ADDENDUM NUMBER TWO

Entitled: BL065 - Optometry School – First Floor Renovations
(IU20250150)

Owner:
Trustees of Indiana University
Bloomington, IN 47408

Addendum Dated: 30 March 2026

**DEMOLITION PLAN -
FIRST FLOOR BL065**

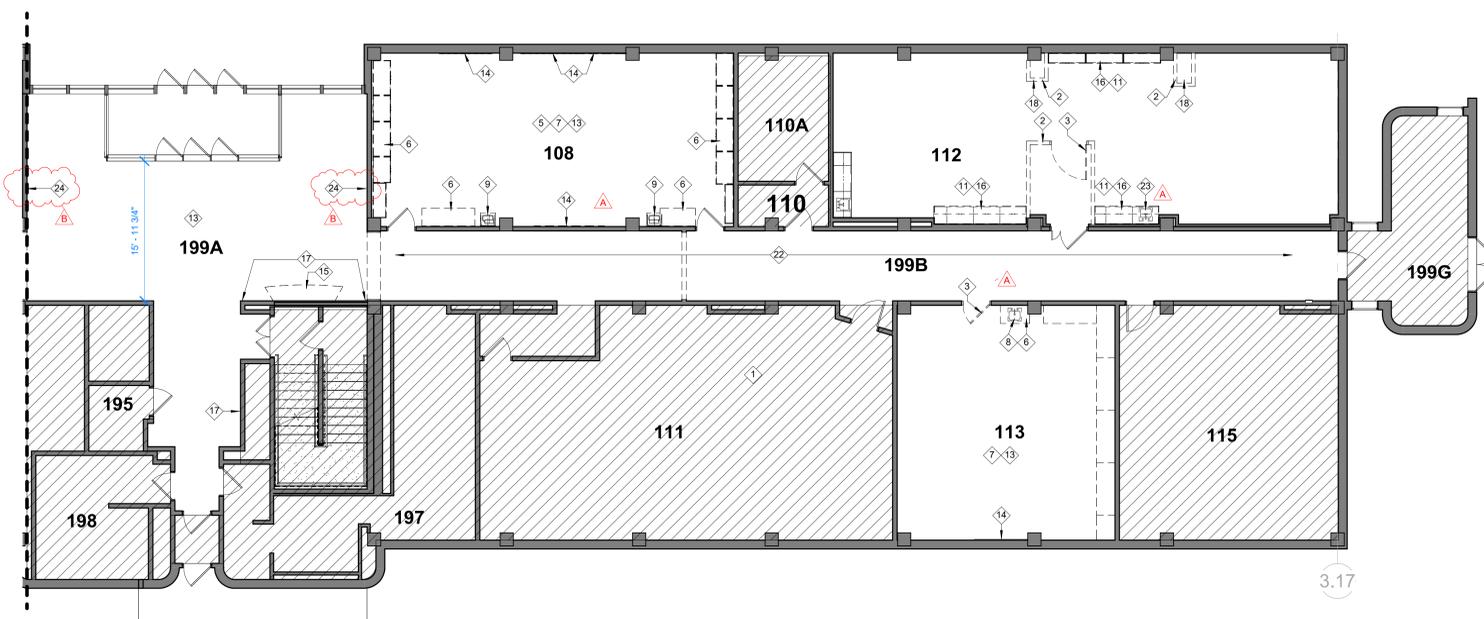
- 1. A091 DEMOLITION PLAN – FIRST FLOOR BL065
 - a. Added note #24 to the Lobby.
- 2. A131 REFLECTED CEILING PLAN – FIRST FLOOR BL065
 - a. Additional information added to L1 in the Light Fixture Legend.
 - b. Added note #11 to the Lobby.
- 3. A420 INTERIOR ELEVATIONS
 - a. Updated monitor locations in the Lobby.
- 4. ED101 – ELECTRICAL DEMOLITION PLANS – FIRST FLOOR
 - a. Delete and replace sheet ED101 in its entirety.
- 5. E-601 – ELECTRICAL SCHEDULES
 - a. Delete and replace sheet E-601 in its entirety.

- 24 PATCH WALLS AS NEEDED WHERE SURFACE RACEWAY IS REMOVED BY OWNER.

REFLECTED CEILING PLAN - FIRST FLOOR BL065

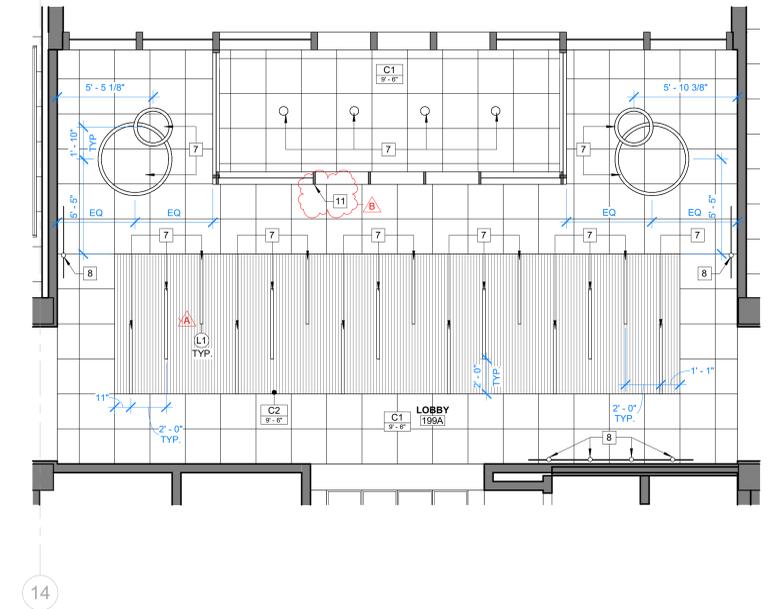
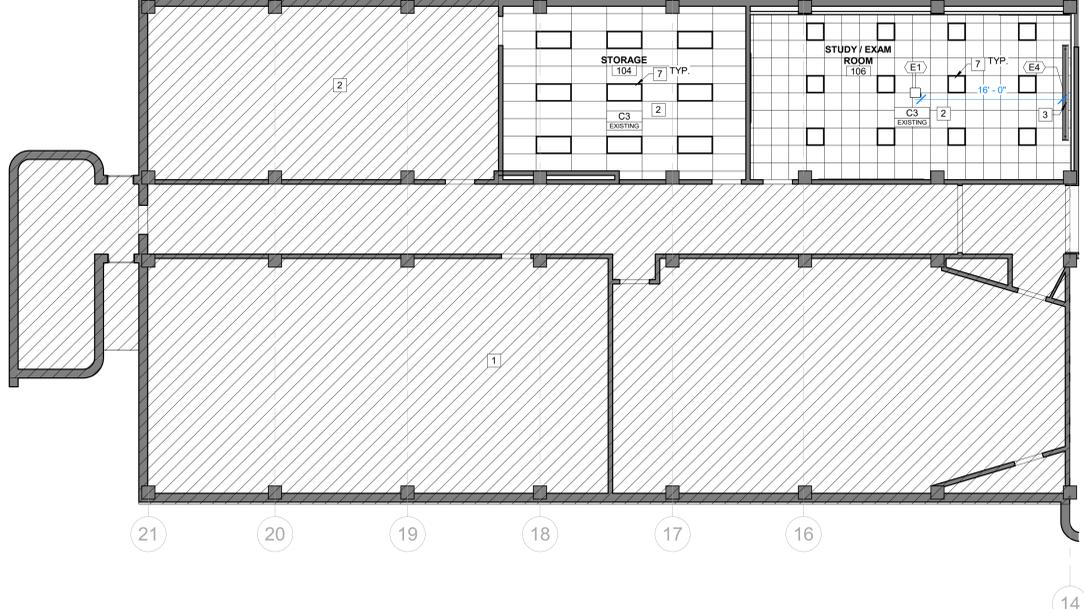
- 11 GC TO PURCHASE AND INSTALL ULINE 26" CONVEX SAFETY MIRROR, H-1548-I, AND USE BRACKET SET H-1548BRACKET TO ATTACH TO STOREFRONT MULLION, COORDINATE LOCATION WITH OWNER.

- L1 TYPE: RECESSED LINEAR
MFG: BASO
STYLE: PANO 2 GRILLE CLASSIC, 120V / 277V, 3500K, CRI > 80, BLACK POWER FEED LENGTH: 4" STANDARD INTEGRATED MOUNTING, INTEGRATED LIGHT CONNECTION CLIP BY ARMSTRONG W/ PANO INTEGRATION BRACKET
